Installation of New ALPS Treated Water Dilution/Discharge facilities and Related Facility

March 18, 2022

Tokyo Electric Power Company Holdings, Inc.

Responses to issues pointed out* at the Review Meeting on the Implementation Plan Regarding the Handling of ALPS Treated Water

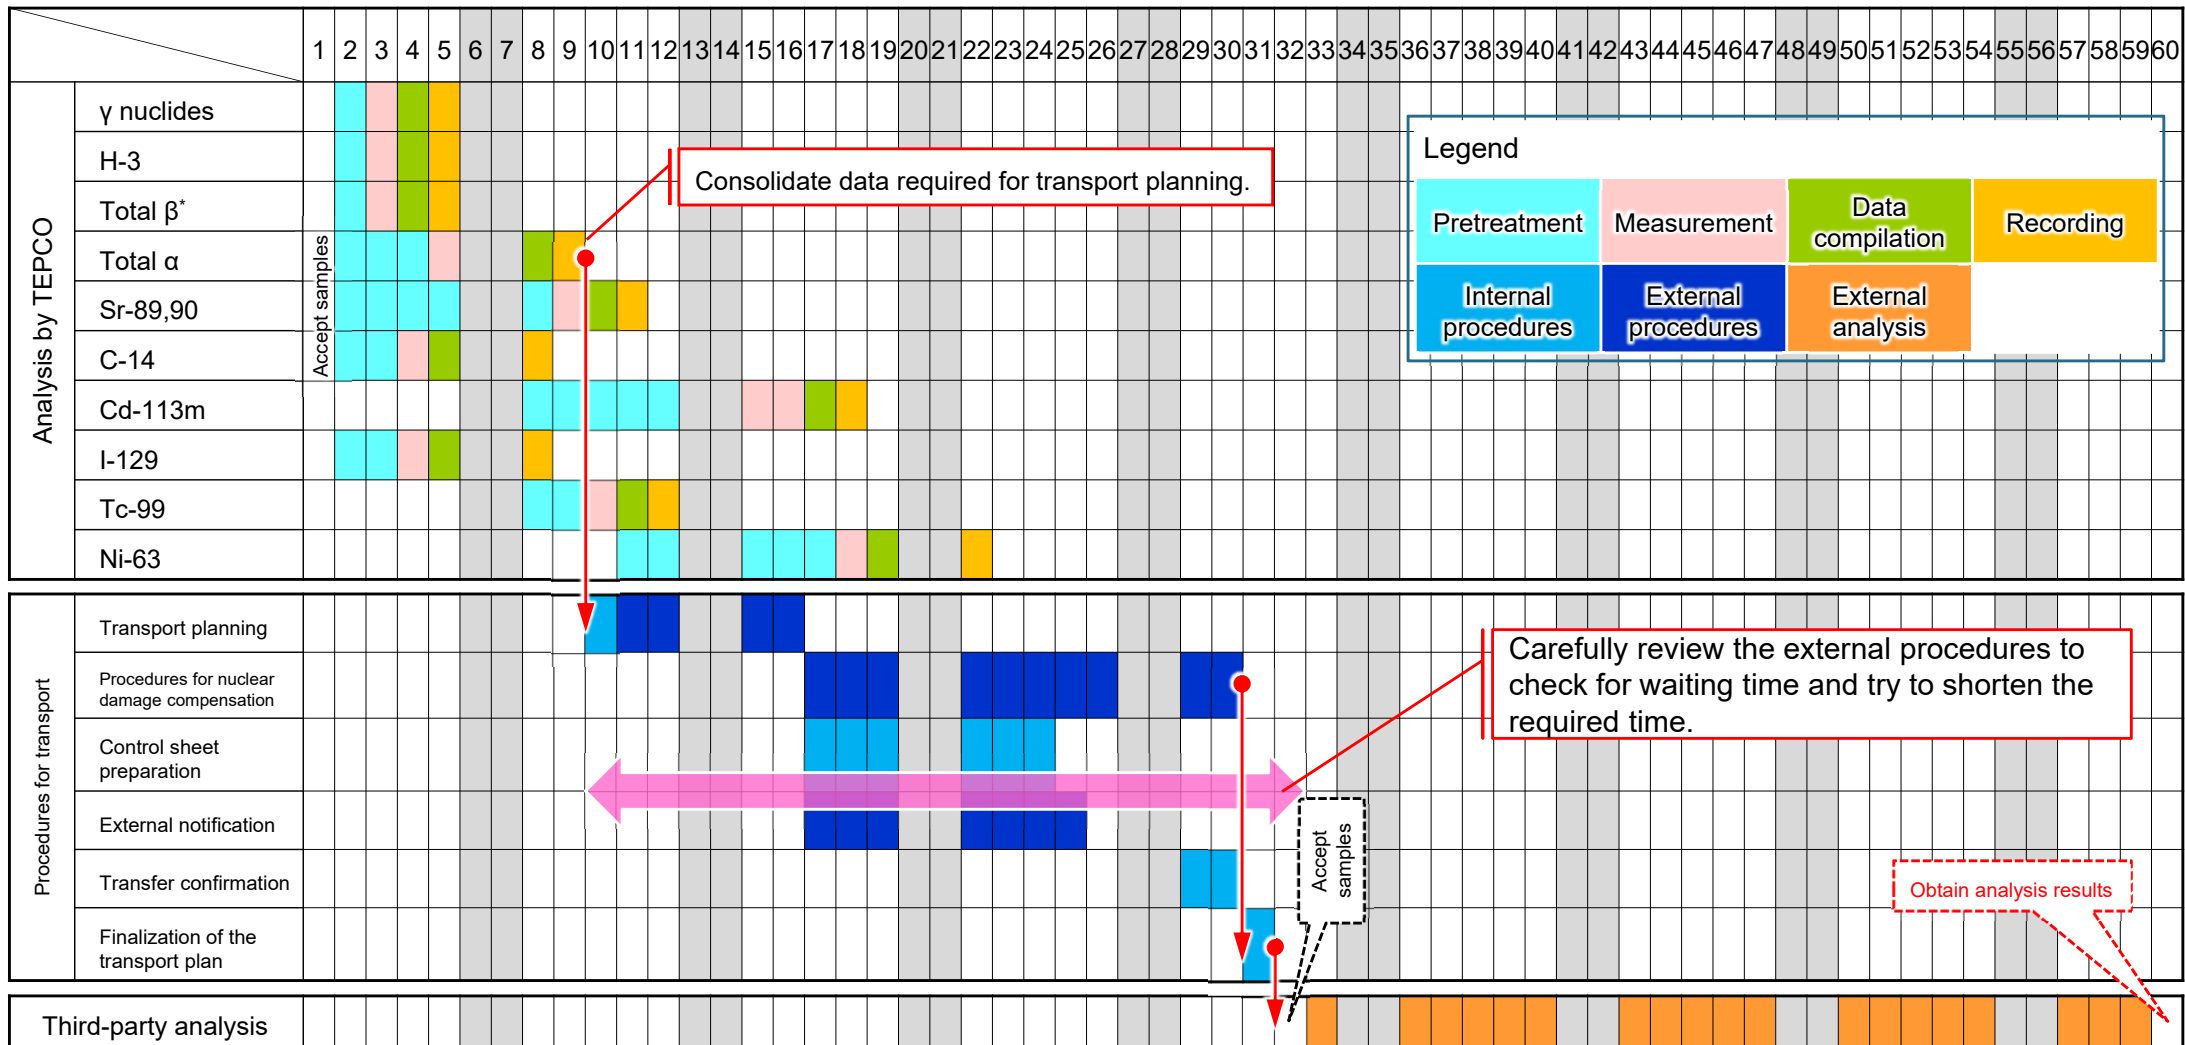
- In the analysis of ALPS treated water, an explanation should be given on what and when each analyst does. Grounds should also be provided that necessary resources will be secured before the discharge by estimating the training period required for the analysts to acquire the prescribed competence.
- An explanation should be given whether or not securing time for training to ensure competence will impact the existing analytical work.
- It should be indicated that parallel analytical work is possible by securing the necessary measurement equipment and analysts based on the increasing number of tritium analyses. In addition, whether each analyst is competent for tritium analysis should also be clarified.

- The current area of about 1,500 m² will be expanded by about 600 m² to about 2,100 m².
- The number of analyzers may increase or decrease depending on monitoring plans and the detailed design of facilities to be determined.
- The construction work is scheduled to be completed by the end of FY 2023.

2-1 (1) [1] Control and monitoring of mixing/dilution ratio of ALPS treated water with seawater [Reference] Uncertainty in mixing and dilution in seawater pipe (2/2)

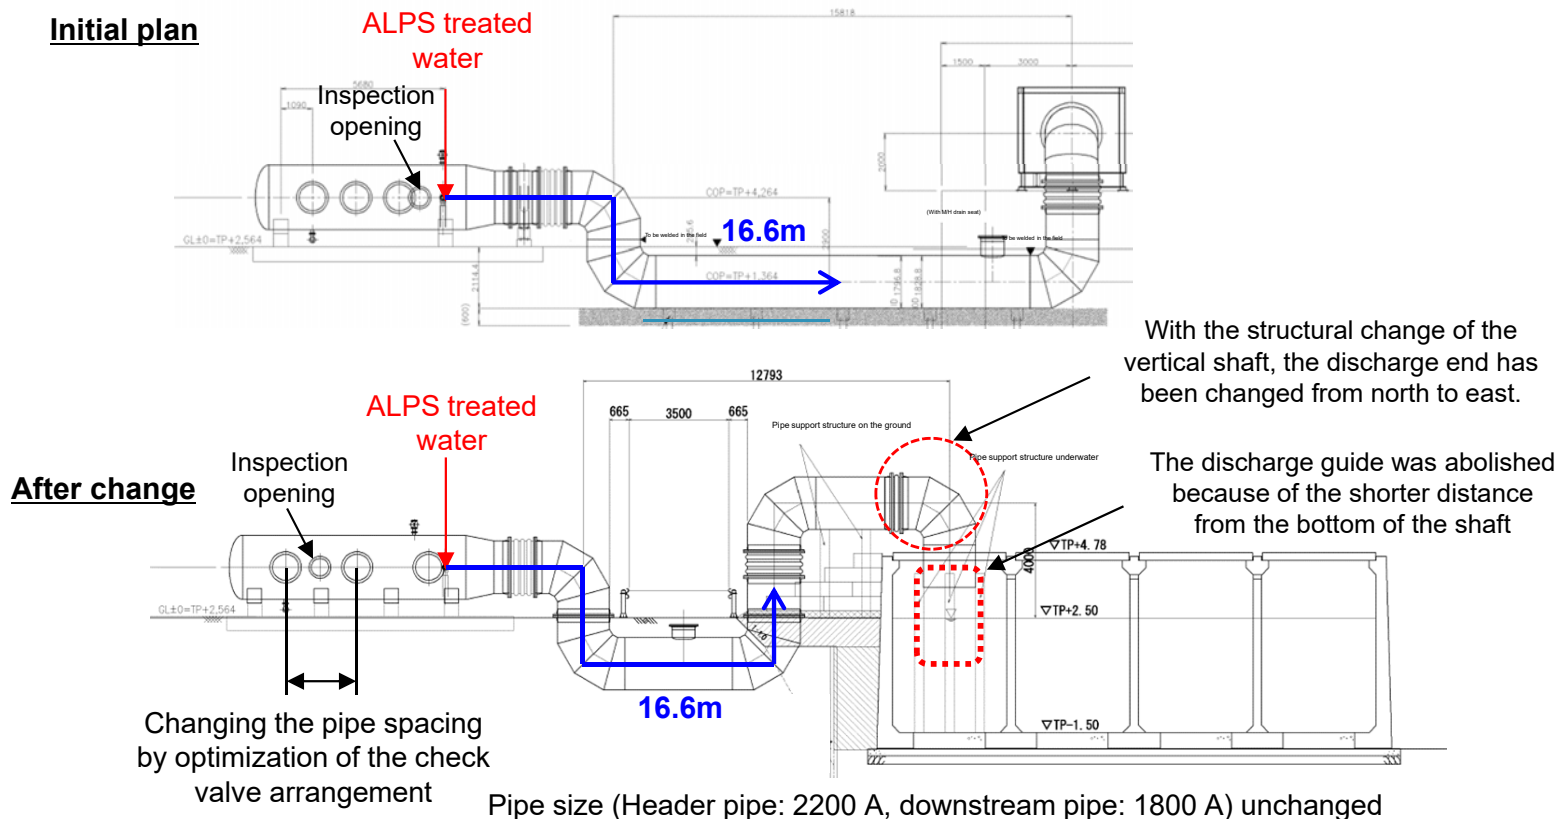
- For the reanalysis of the mixing/dilution simulation after the shape change of the seawater pipe, the concept of the analytical conditions (ALPS treated water flow rate, tritium concentration, etc.) and the impact of these uncertainties should be explained.
- When setting tritium concentration (operational value) after dilution with seawater, it is stipulated that 1,500 Bq/L should be set with a sufficient margin. However, the upper limit of the set point should be evaluated in advance with anticipation for an event that more ALPS treated water is discharged than planned transiently due to trouble, etc.

- At present, a reanalysis of the mixing and dilution simulation after the shape change of the seawater pipe is underway.

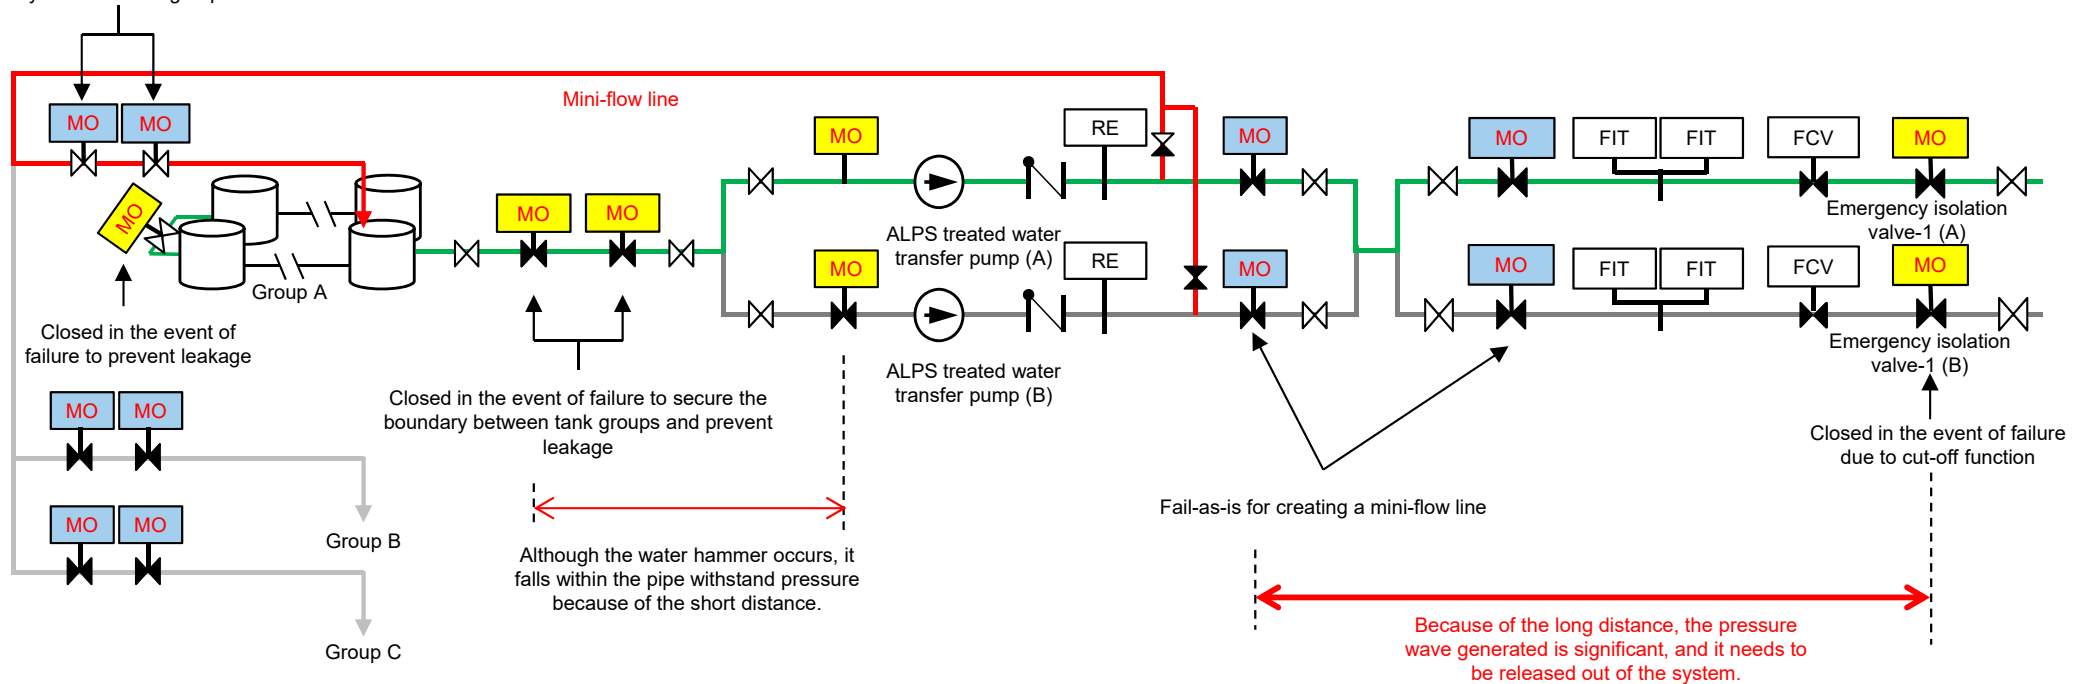
- On the other hand, if the emergency isolation valve-1 (MO valve) with a fail-close function and the valve of the same type are closed simultaneously due to a loss of off-site power supply or other events, the pressure wave generated in a part of the transfer pathway will exceed the pipe withstand pressure. Based on this, the operating conditions will be changed to have the mini-flow line path, as shown in the figure below.

Fail-as-is to prevent water hammering and secure the boundary between tank groups when an event occurs

leakage incidents at specified nuclear facilities since the 3.11 Earthquake: 190 cases

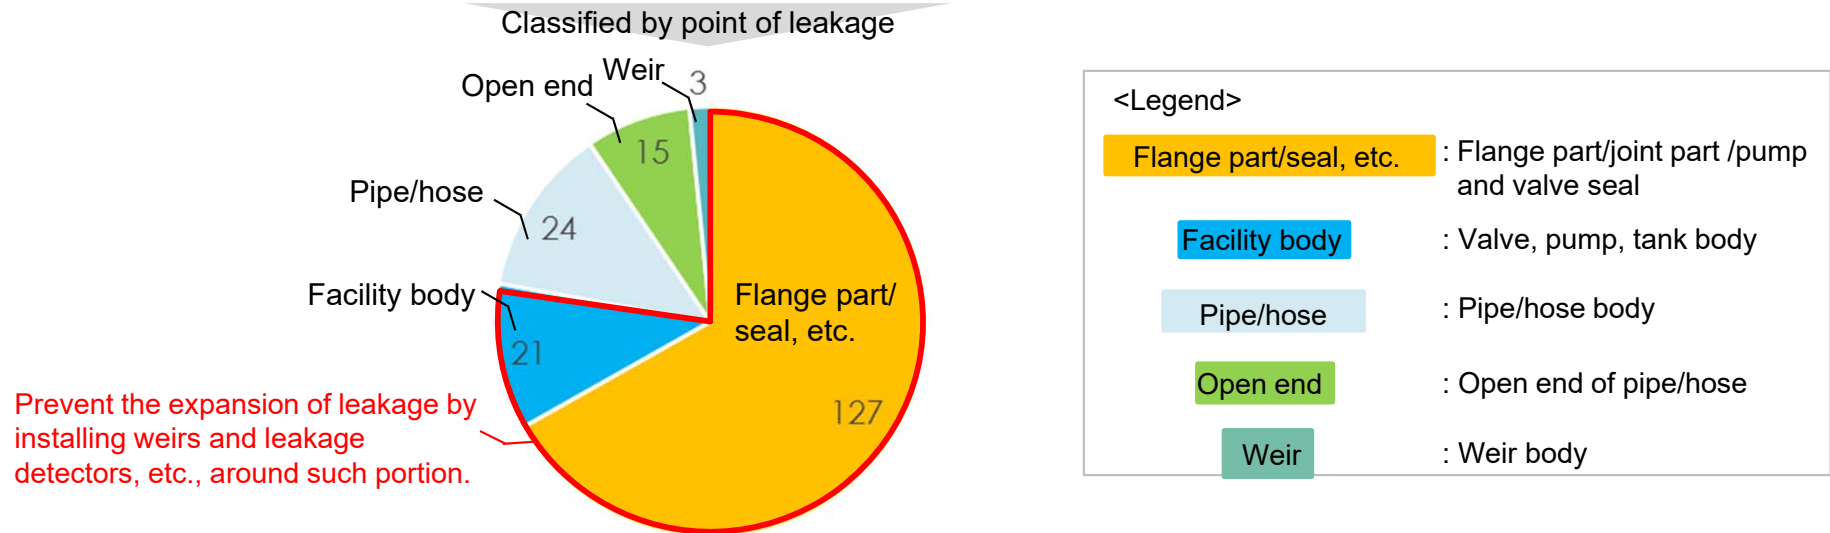
- As measures to prevent the spreading of leakage in the ALPS treated water dilution/discharge facilities, weirs will be installed around the circulation pump, ALPS treated water transfer pump, an emergency isolation valve, and inside the weir a leakage detector will be placed.
- A leakage detection alarm will be displayed such as in the central monitoring room of the seismic isolation building. Operators will check the status of operation monitoring parameters such as flow rate, so that they take appropriate measures such as operating and shutting down the pump. (Implementation Plan II-50-Attachment 2-1).
- Specifically, when an alarm of leakage detection is issued, operators promptly stop the discharge of ALPS treated water into the sea to prevent the expansion of leakage.

- Leakage incidents, which have occurred at the Fukushima Daiichi NPS since the 3.11 Earthquake, are the incidents most likely to occur from the facilities themselves, such as flanges and seals (see the figure below).
- Based on this, in the ALPS treated water dilution/discharge facilities, to prevent the leakage from the main body of the facility such as flanges/seals, weirs and leakage detectors will be installed around such portion.
